Planning Re-Appn. APP/17/00186
Re: 35 North Shore Road, Hayling Island

Changes proposed by Mrs Ormsby 11 Feb

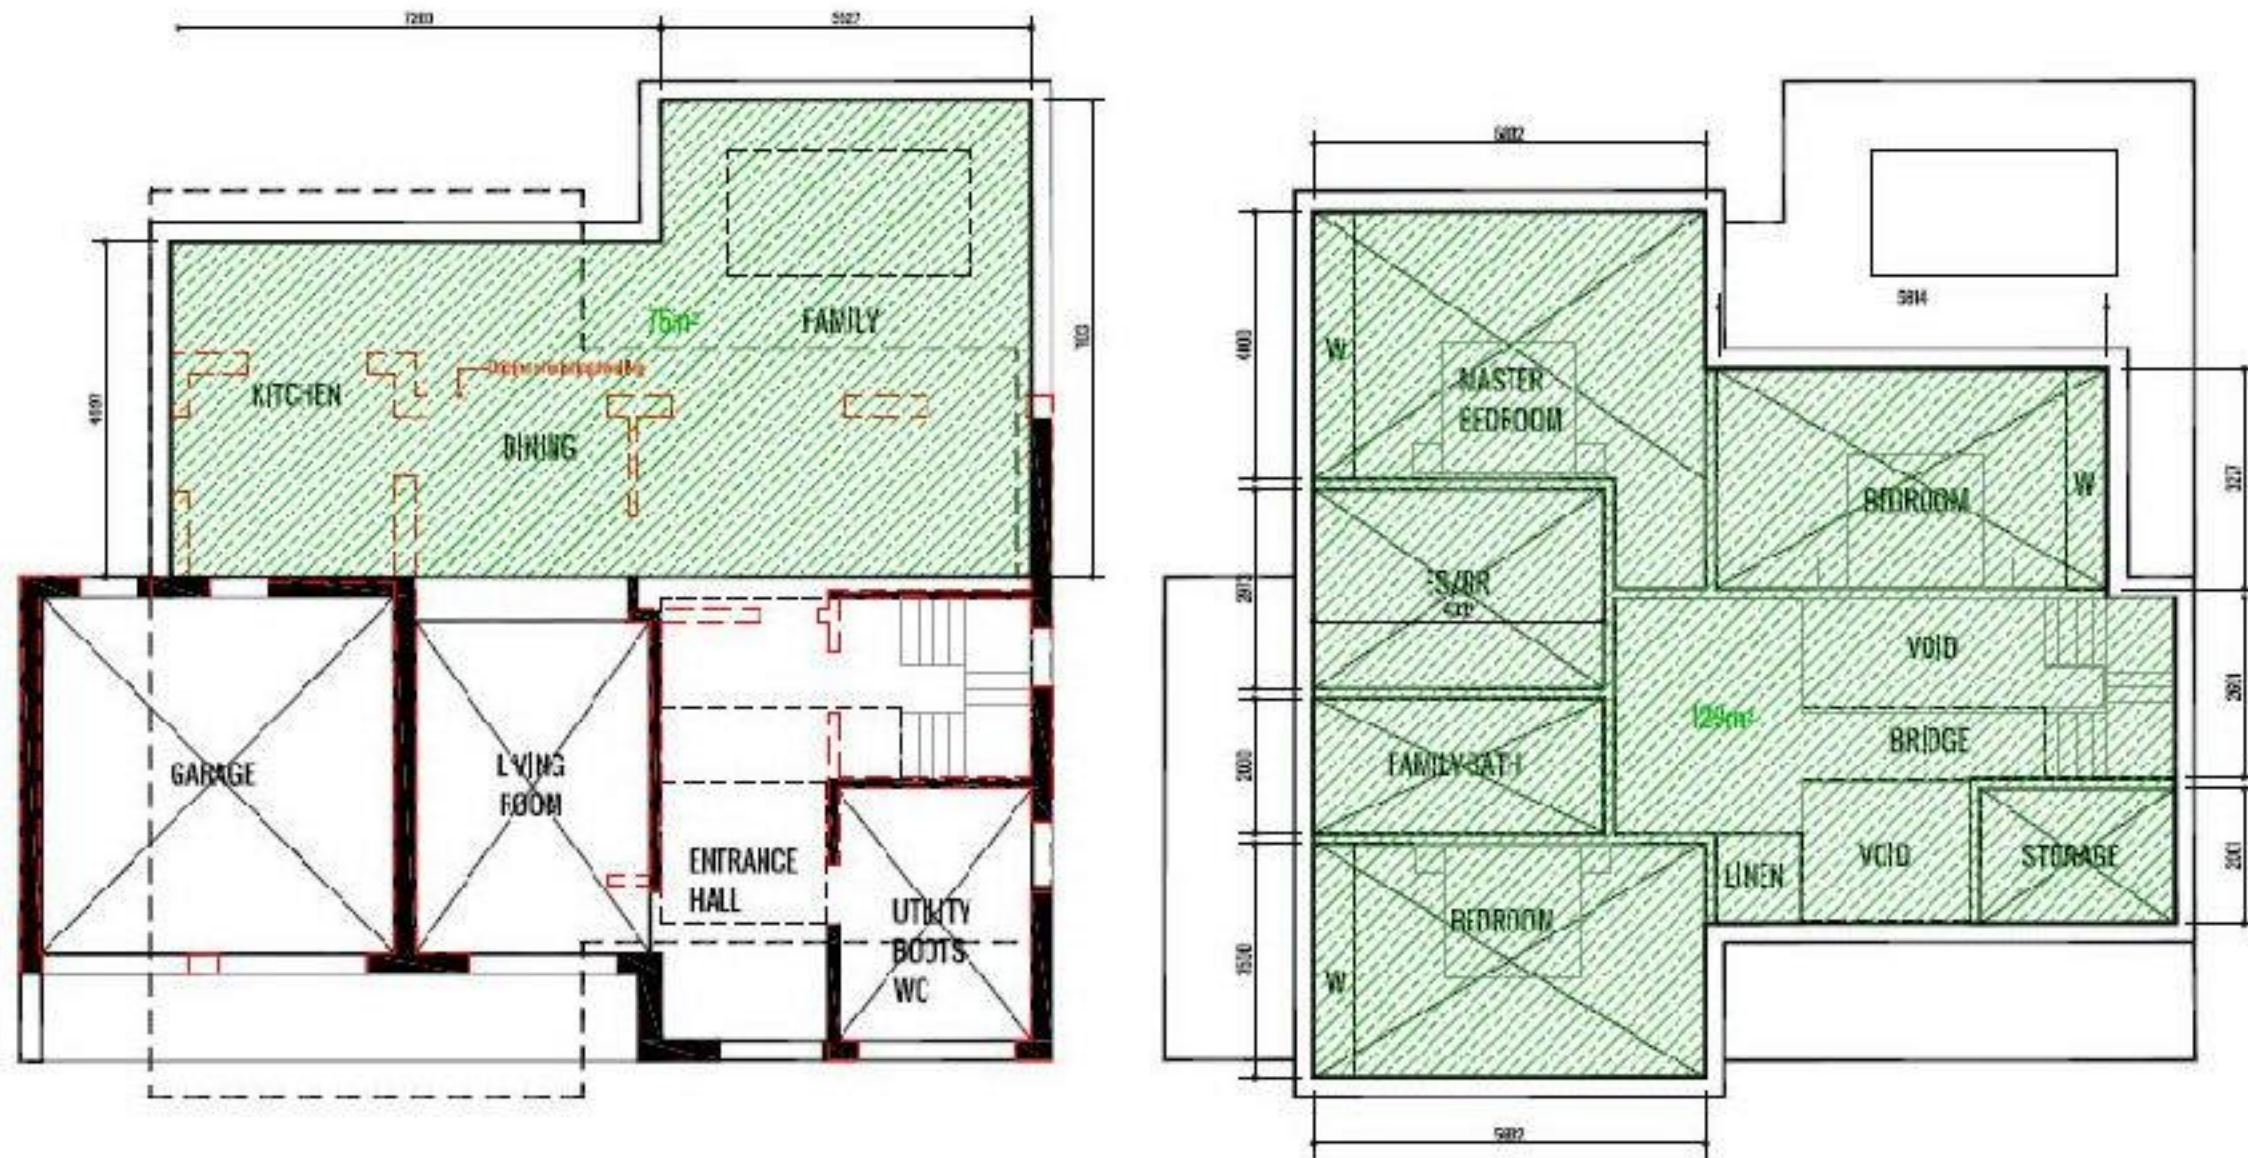
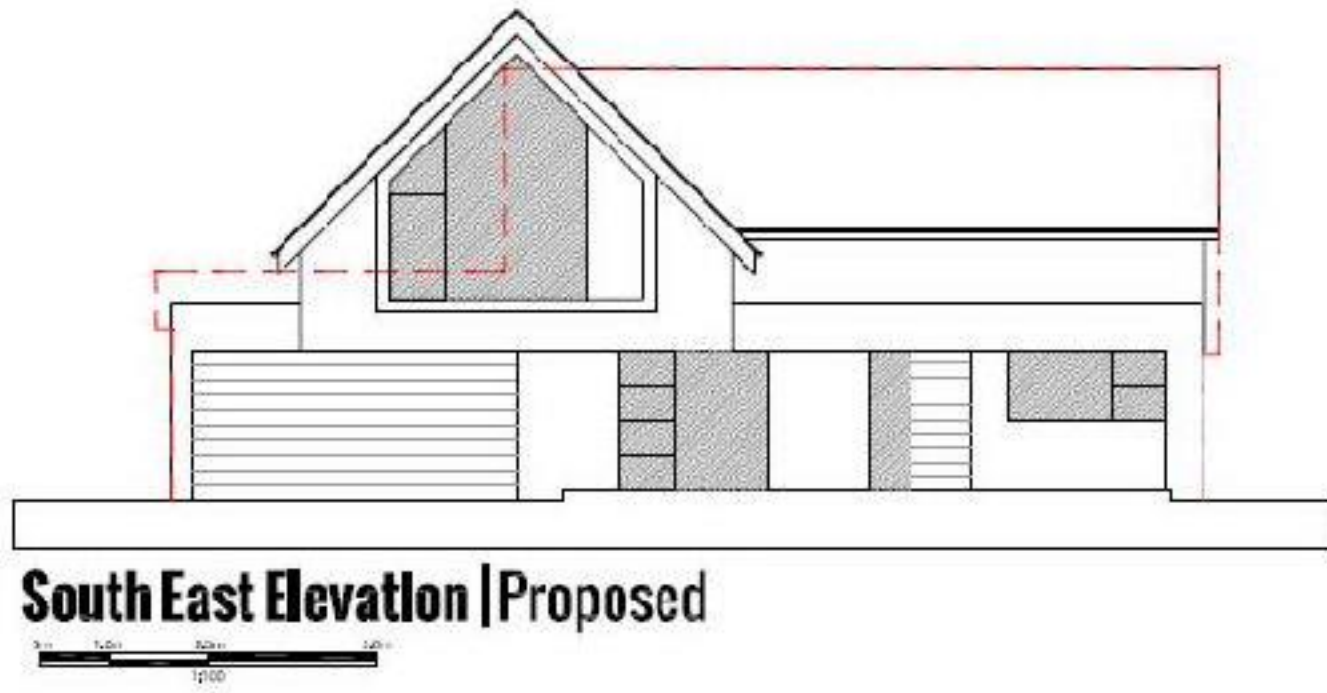
1. The ridge height is reduced to match that of immediately adjacent neighbouring properties. This is a welcome amendment to me at 37 North Shore Road and may also satisfy Lyall Cairns' concerns on behalf of Langstone Harbour Board.

2. The gable has been moved in a south-easterly direction to the other end of the house. This will significantly reduce the over-bearing and shadowing effect that the former gable roof would have had over my property located, as it was, immediately to the south-west or up-sun.

3. The final change proposed by Mrs Ormsby in the plan has been to scale back the first floor extension at the north-east corner by, as far as I can measure just onscreen, about 1.5m-1.75m from the existing south-east facing front wall at ground-floor level. This would have the effect of assisting somewhat in mitigating the overshadowing of my first-floor bedroom window and dining room windows beneath.

Changes number 1 and 2 above are both extremely welcome but I do have some residuary concerns about the scale of mitigation provided by change number 3 which I will detail on the following page - below the plan received from Mrs Ormsby.

1. be assured in my assumption that the ground-floor front wall at the northeast corner does not extend its “building line” any further in a south-easterly direction towards the roadway?
2. receive a revised north-east elevation showing, as previously, a red-dotted line outline of the existing elevation so that I can properly appreciate the proposed change (please refer to the previous NE elevation reproduced below)
3. understand why the newly-submitted NE elevation now shows a blank area at ground-level (highlighted in yellow just below for your convenience) where there had previously (see earlier submission on page 4 below) been a window and a side-door?:-

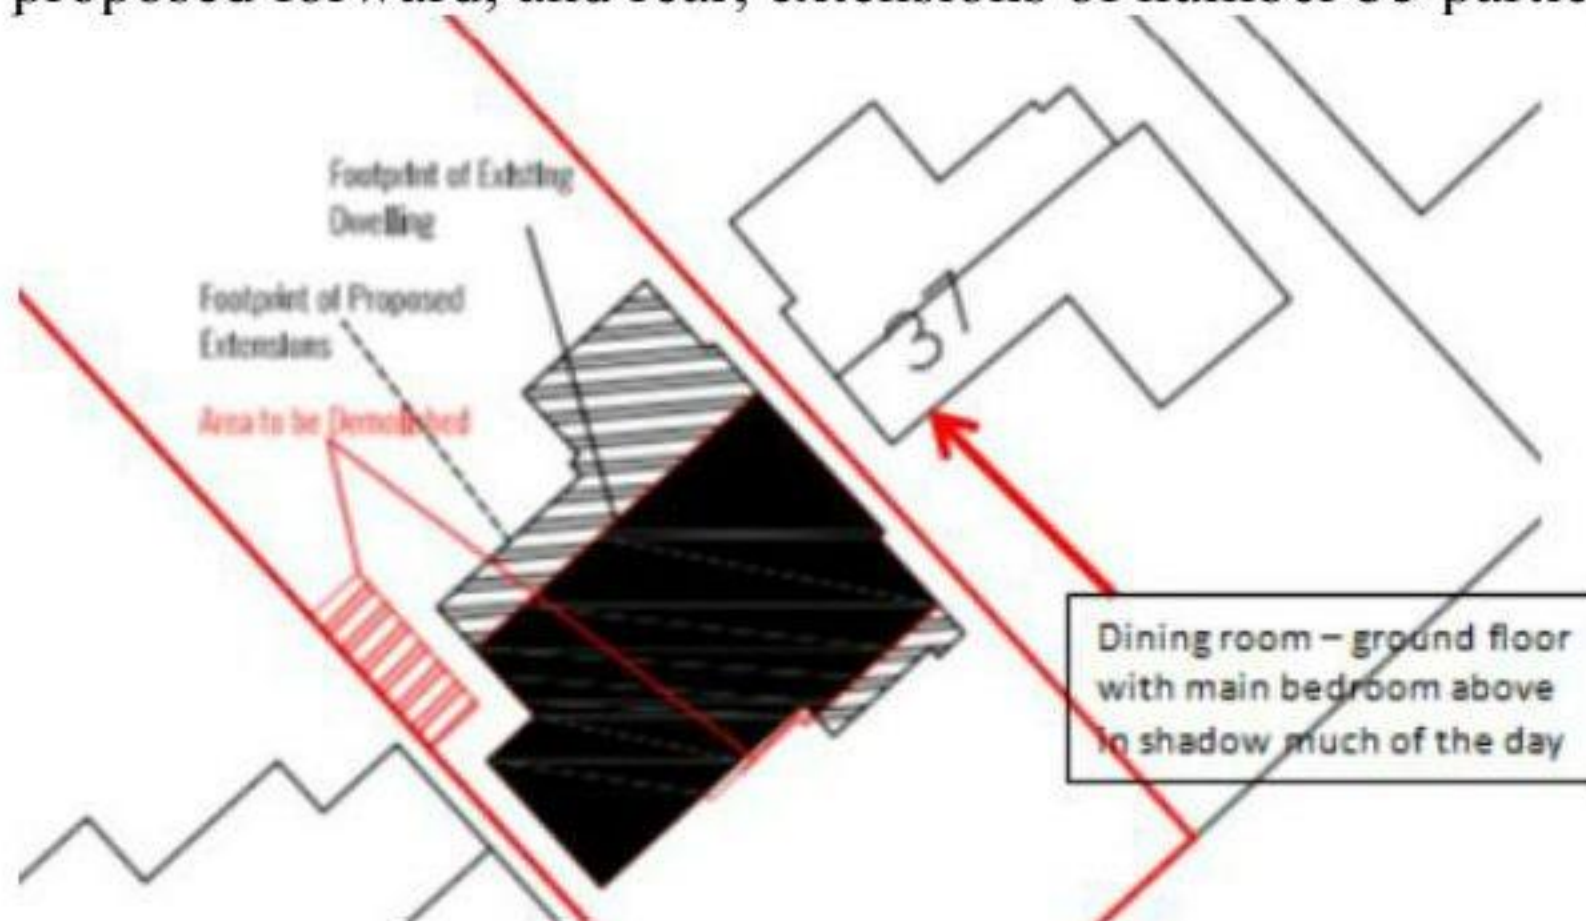
The scale of the pre-existing ‘shadowing’ problem, even with the sloping roof and dormer windows at first floor level, can best be appreciated from this Google Earth photo taken in the early afternoon and copied below:-

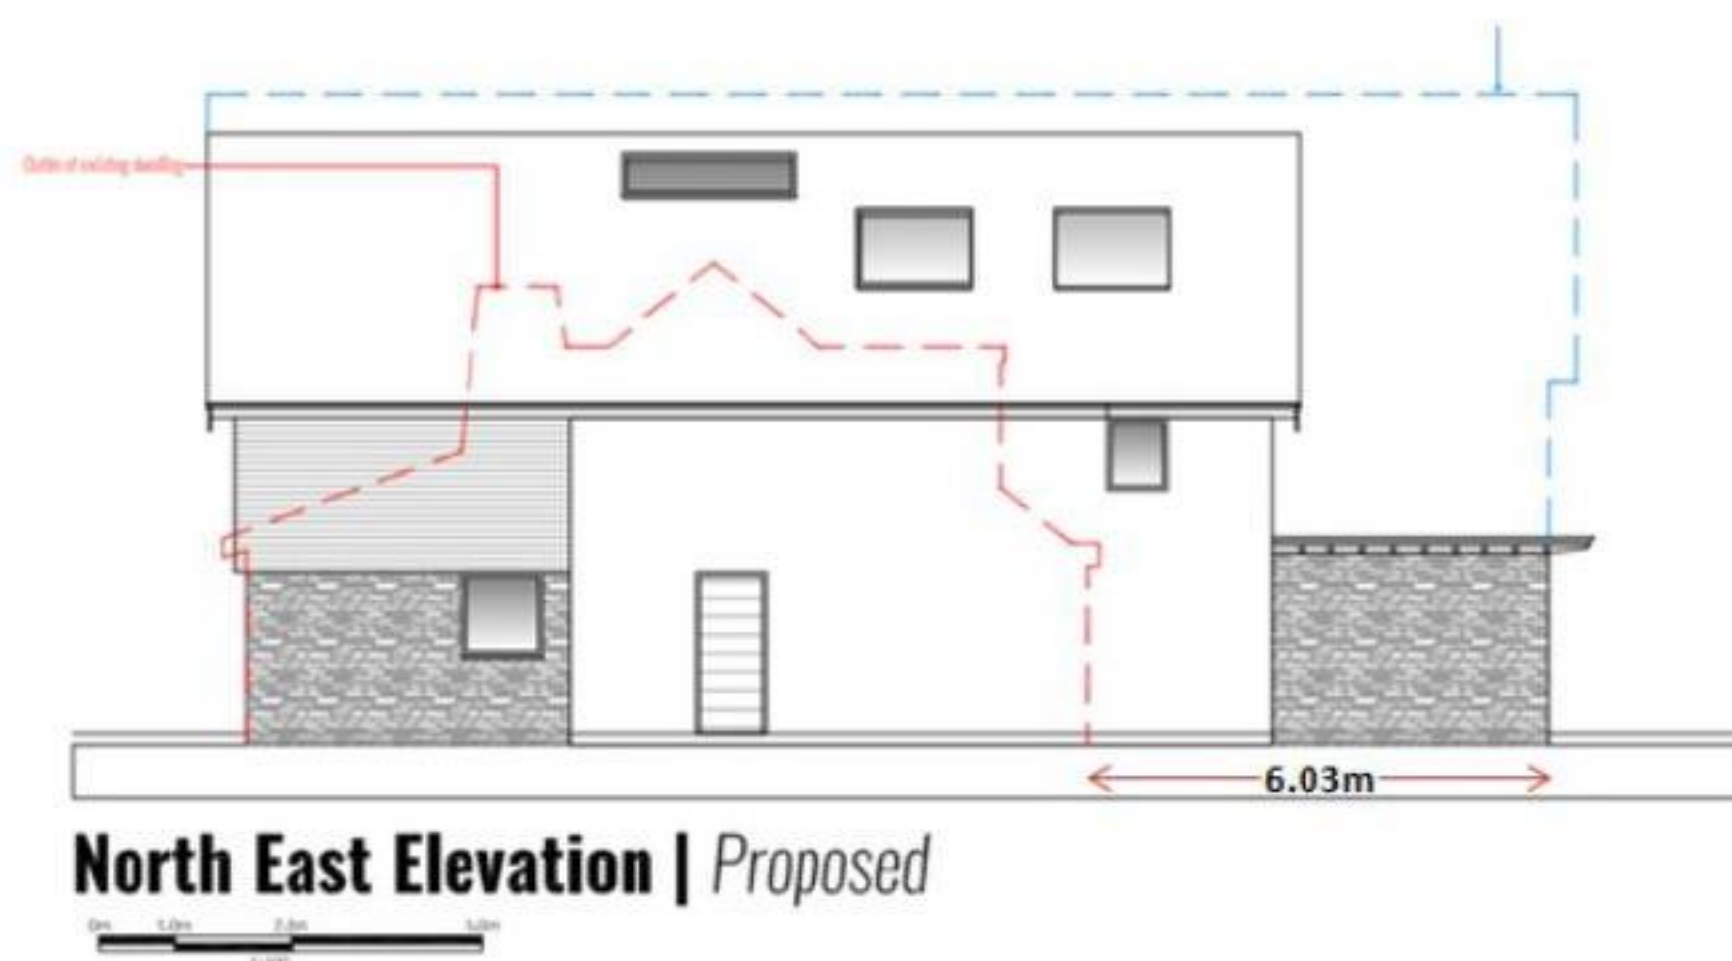
The subject property is positioned towards the south and south west of my home and I am concerned that my ground floor dining room window and bedroom window above, as well as the living room to the rear, would have much of the natural sunlight blocked out by the proposed forward, and rear, extensions of number 35 particularly at the second storey level:-

But in the case of the proposed development the ground floor rear extension is just over double this recommended 3 metre maximum from the rear wall of the existing house (see below):-

The front second-storey extension together with the additional high gable roof both serve to cause serious loss of light from the south/south-west to the front of my house and, in particular, to my dining-room window as well as the main bedroom window above.

Measured from the centre of my **dining-room window** at ground-level, the second-storey extension would be within a combined plane and section 45 degree overshadowing zone.

My front second-storey **bedroom window** would also appear to be within this overshadowing zone.
